MARSHALL CITY PLANNING COMMISSION SPECIAL MEETING

1. Receive and consider Site Plan amendment #SPA17.06 for Delta-One, 1120 Industrial Road

Planning & Zoning Department City of Marshall 323 W Michigan Avenue Marshall, MI 49068 February 5, 2021 SEG Project No. 2017-024

RE: REVISED SITE PLAN SUBMITTAL
1120 INDUSTRIAL ROAD CULTIVATION FACILITY
CITY OF MARSHALL, CALHOUN COUNTY, MICHIGAN

landscape plan for (phase-1): Proposed Farm Facility

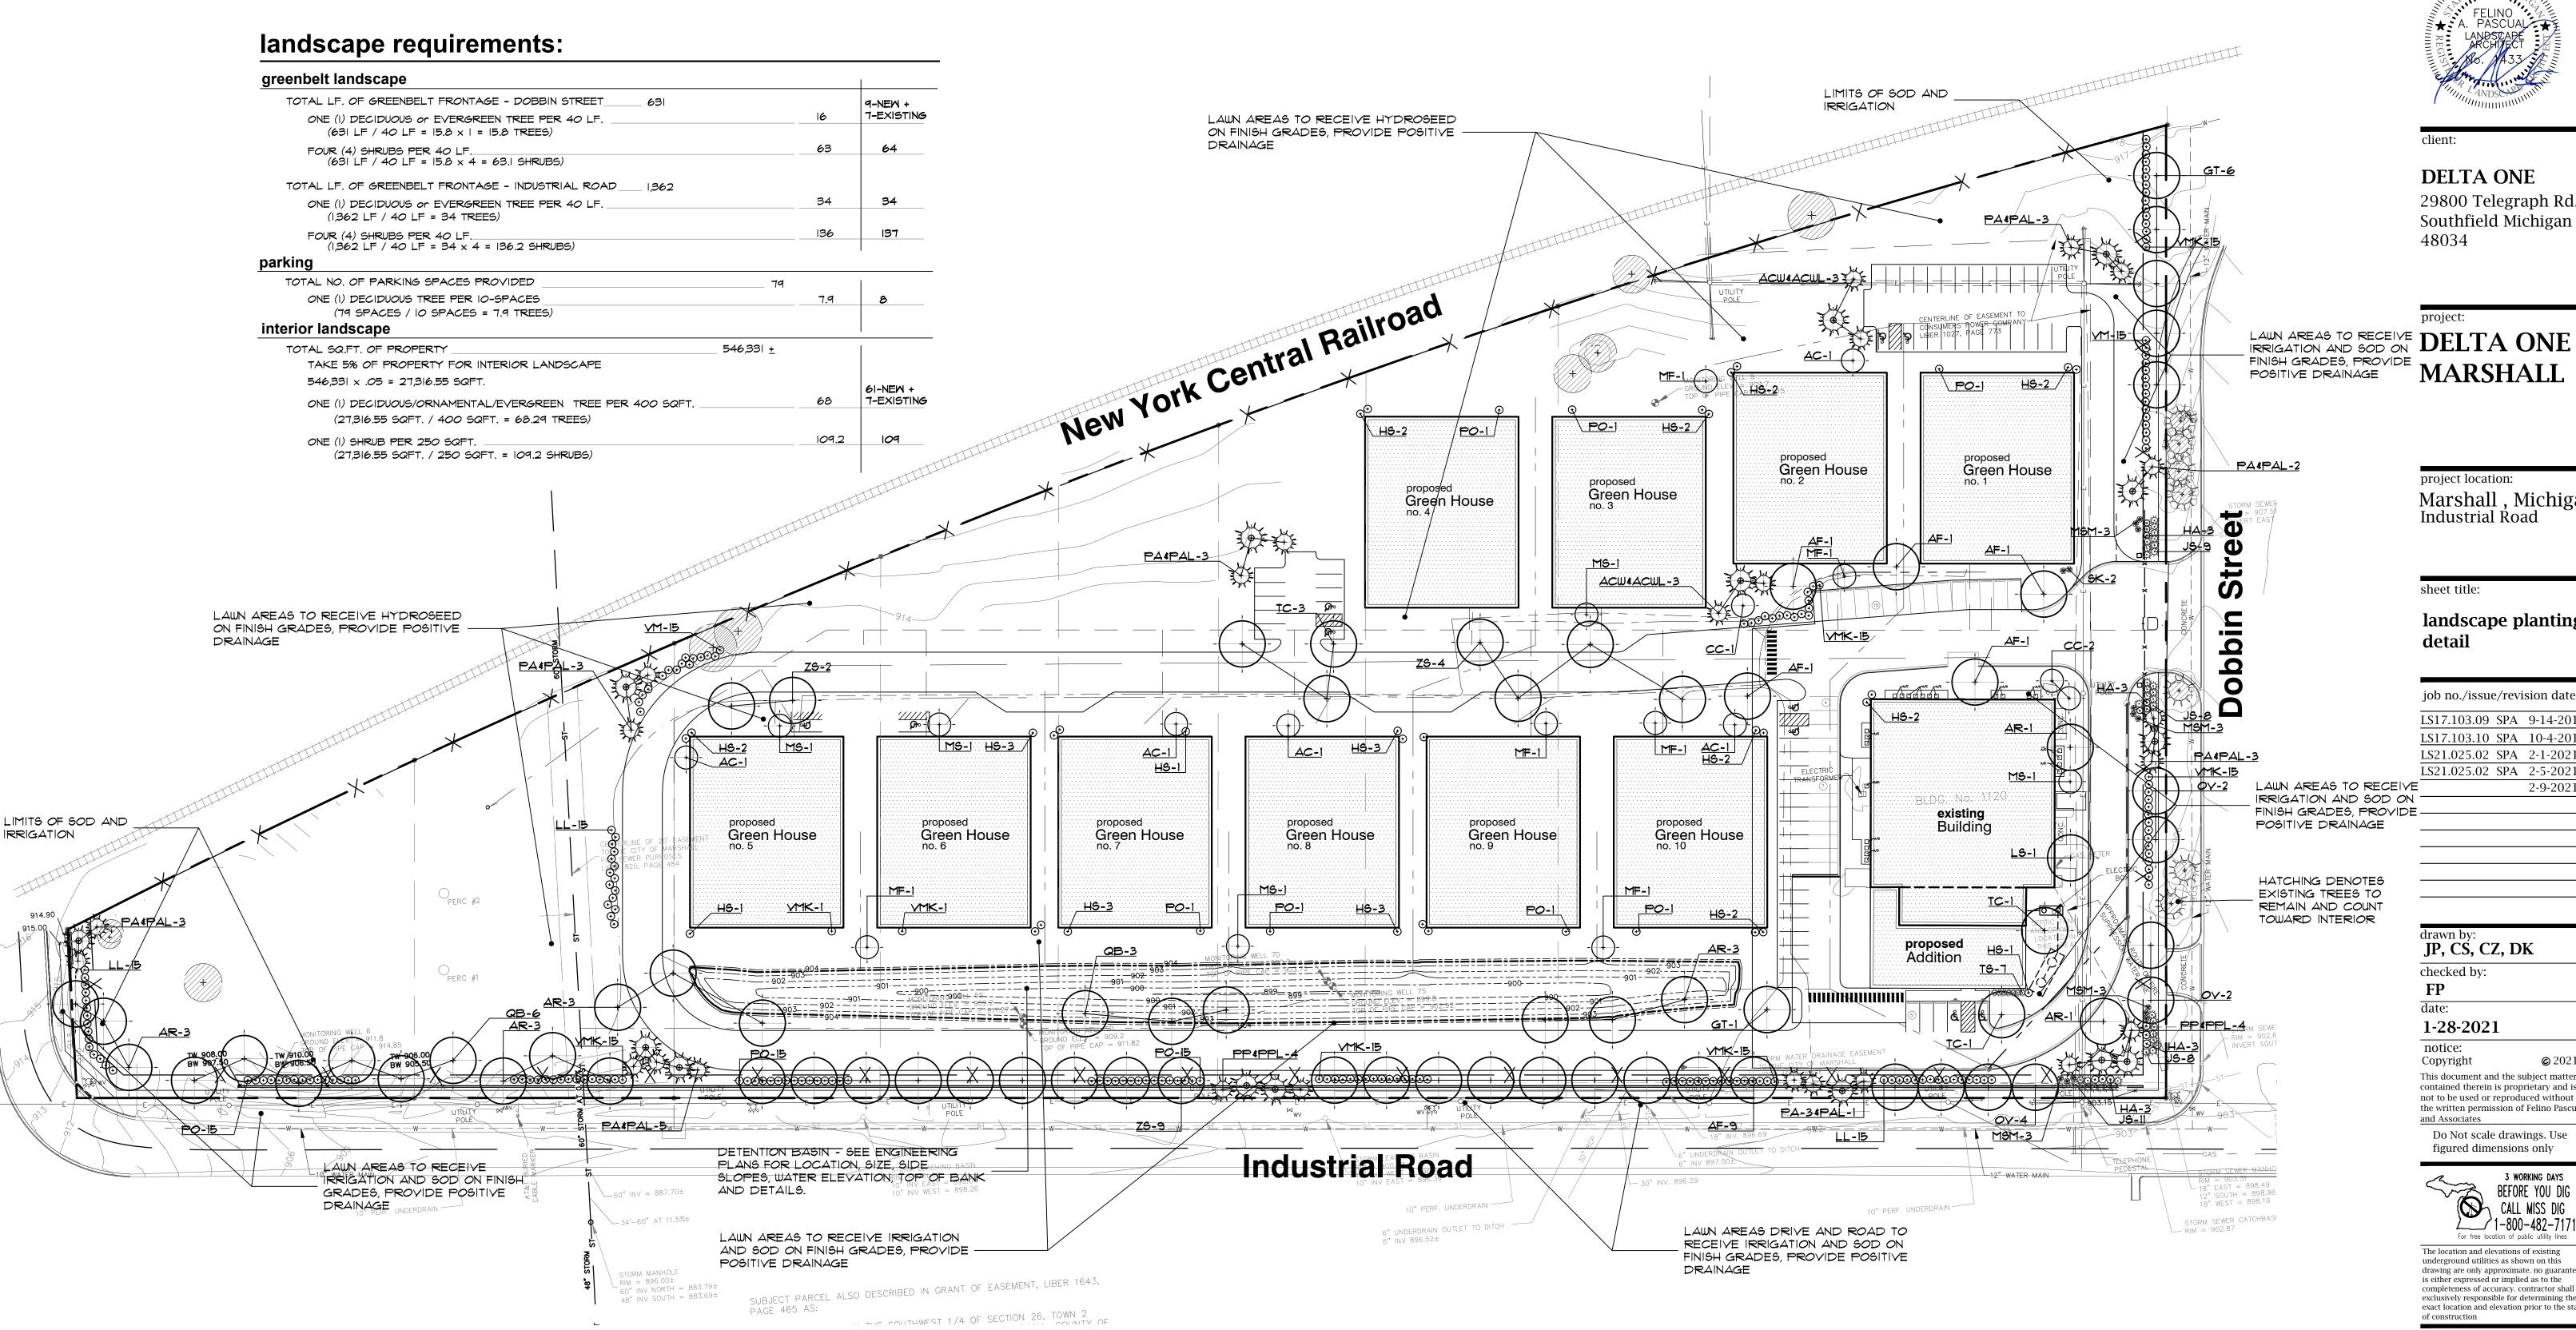
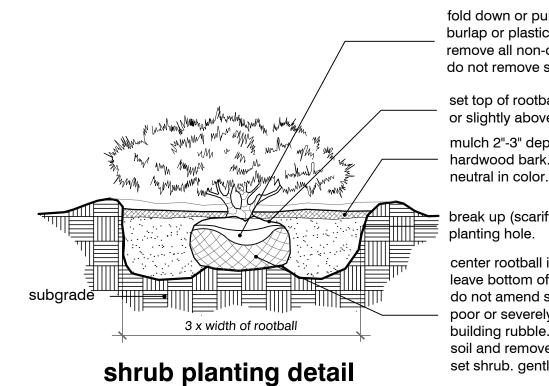
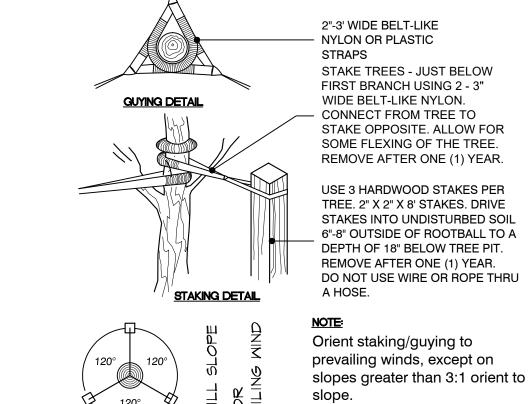
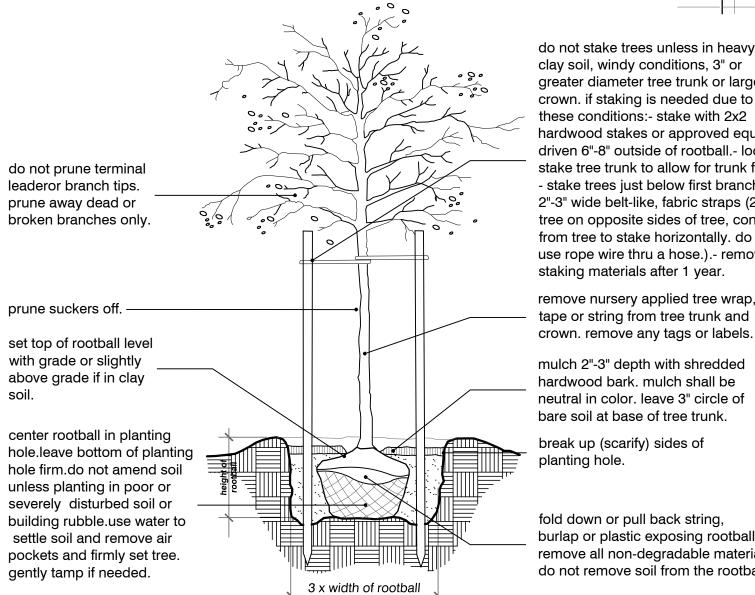
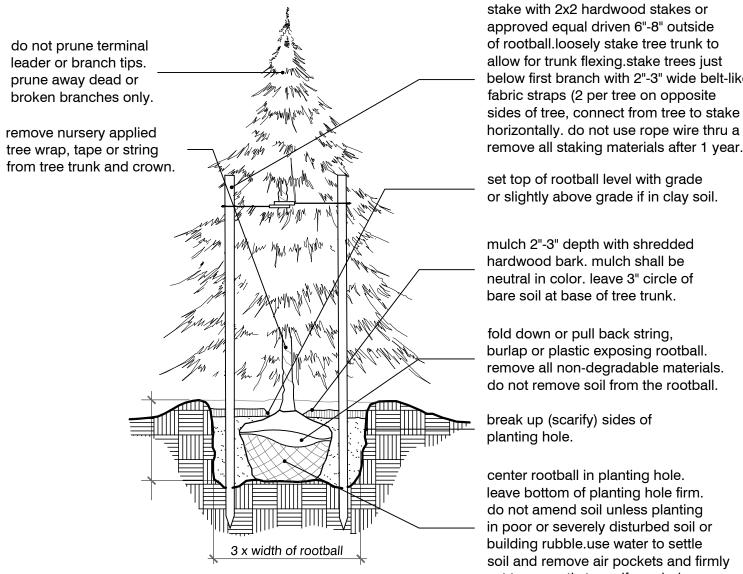
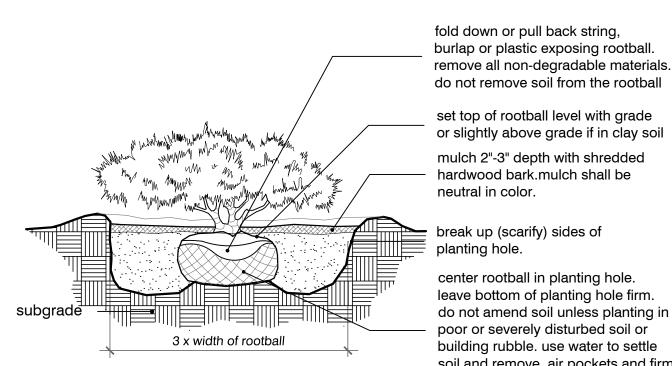
- 4. It was found in order to accommodate the Phase I Landscape Plan some plant material had to be moved around from the originally approved landscape plan. Therefore, the original landscape plan has also been revised accordingly so that it is consistent with the Phase I Landscape Plan, this mainly applies to landscaping that is located along the Dobbins Court street frontage.

* A1 BUILDING ADDITION FLOOR PLAN/ELEVATIONS

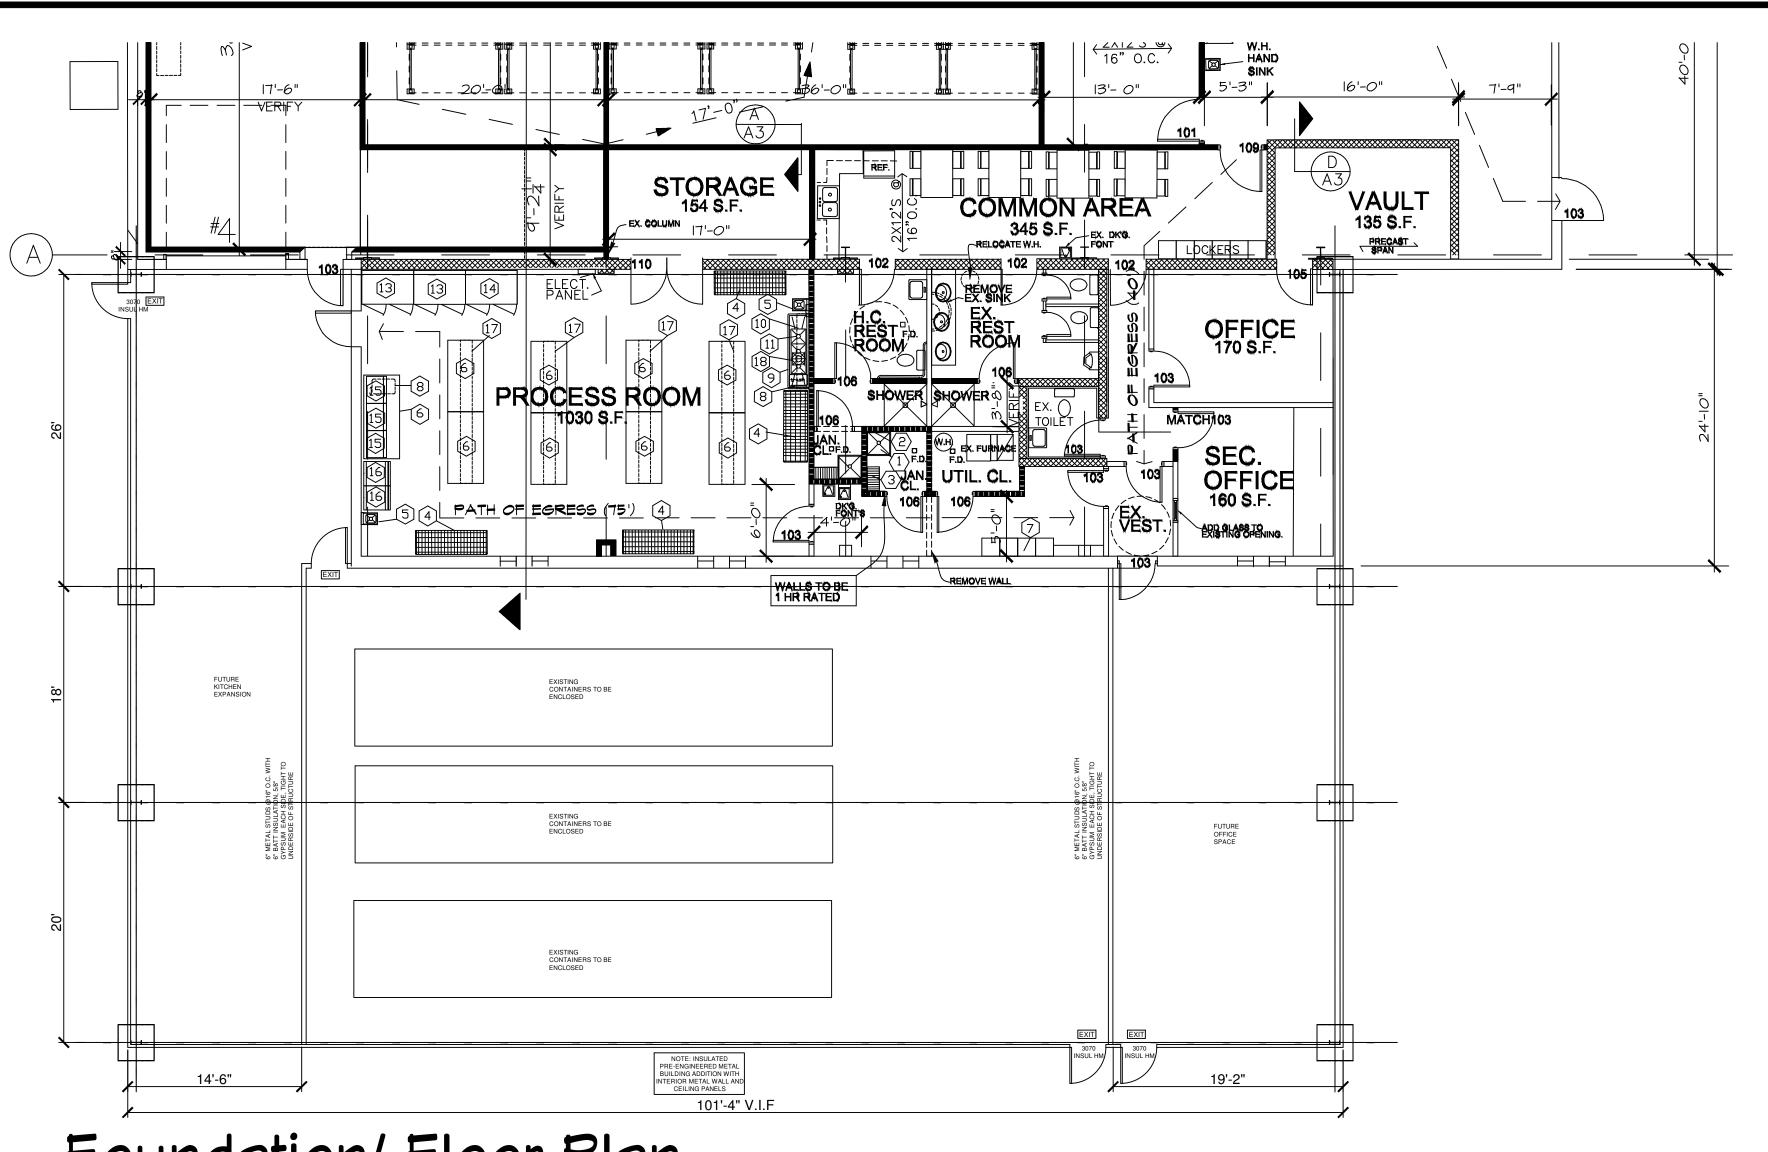
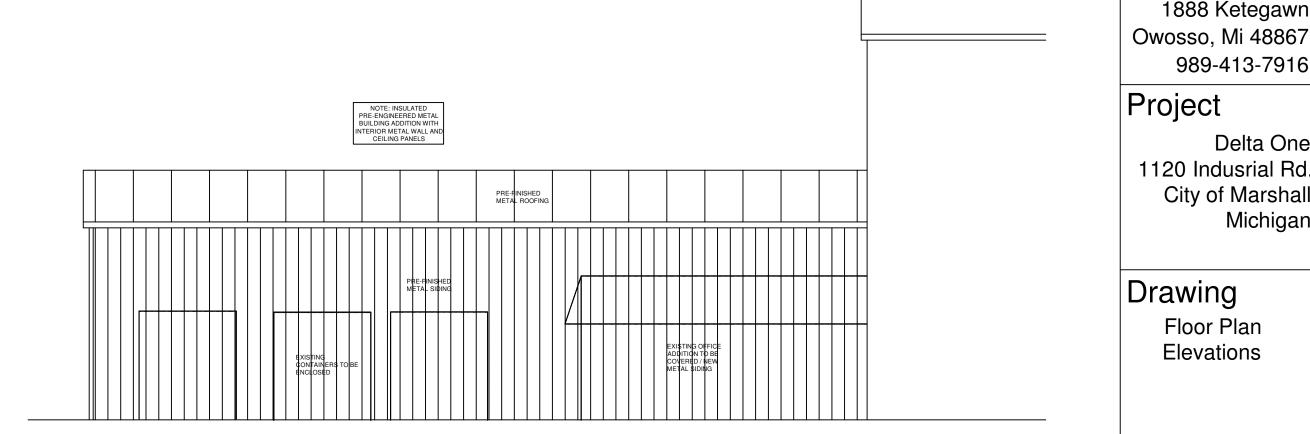
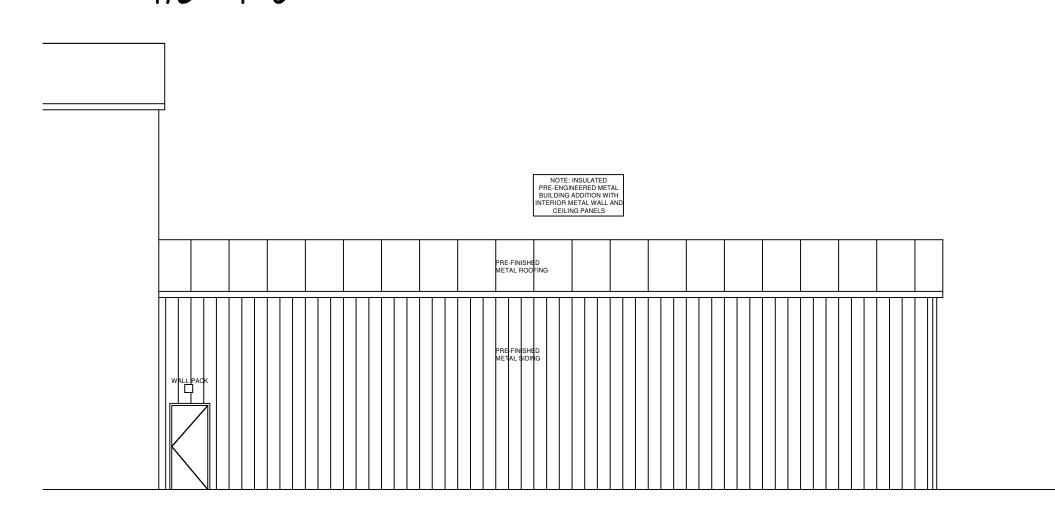
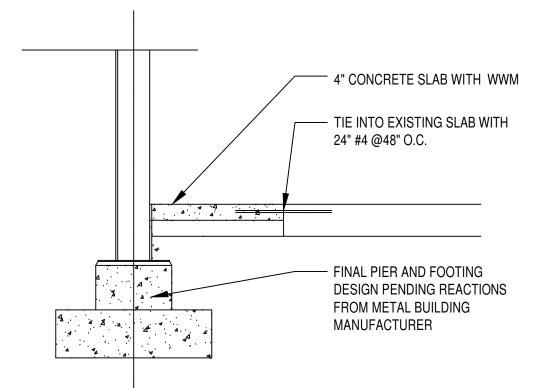
- 3. The developer found that additional mechanical equipment was needed at the Phase I building. Initially it was thought they would need one or two outdoor containers, this evolved into 7 containers. The Phase I Site Plan is now showing the 7 containers but that they will be enclosed under a building addition. The developer will submit details of the enclosure separately.
